# H<sup>®</sup> TECHNICAL BULLETIN

## HAS™ 46K Plus

**SUBJECT:** Aftermarket Service Kit No. 49175-024  
for Severe Service Applications

**LIT NO:** SEU-0103

**FIGURE 1**

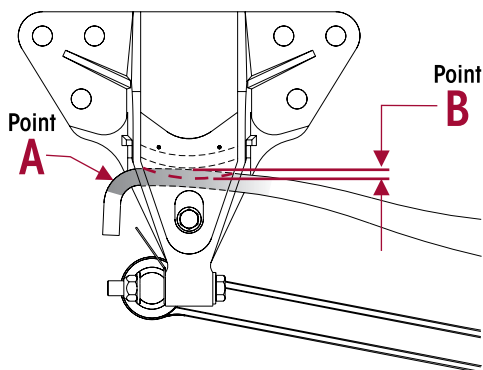
Hendrickson has developed a service kit for the HAS 46K suspension that enhances the durability in logging and other severe service applications. When installed, the service kit upgrades the HAS 46K capacity to an HAS 46K Plus. The service kit has a unique rebound roller design and a main support member that is ¼" thicker at the tip, see Figure 1, Point **A**.

The HAS 46K could be subjected to premature wear that could require the replacement of both main support members and slipper pads. **Service Kit No. 49175-024** plus **new slipper pads** (refer to Hendrickson Parts List, Literature No. SP-149) should be installed in these applications if the HAS 46K main support member exhibits ⅜" or more wear at the frame hanger on the cam surface contact area, see Figure 1, Point **B**.

The HAS 46K Plus service kit includes the necessary components with the exception of the slipper pads to upgrade the HAS 46K to the HAS 46K Plus for one axle. To upgrade the tandem (two axles), it will require two HAS 40K Plus service kits.
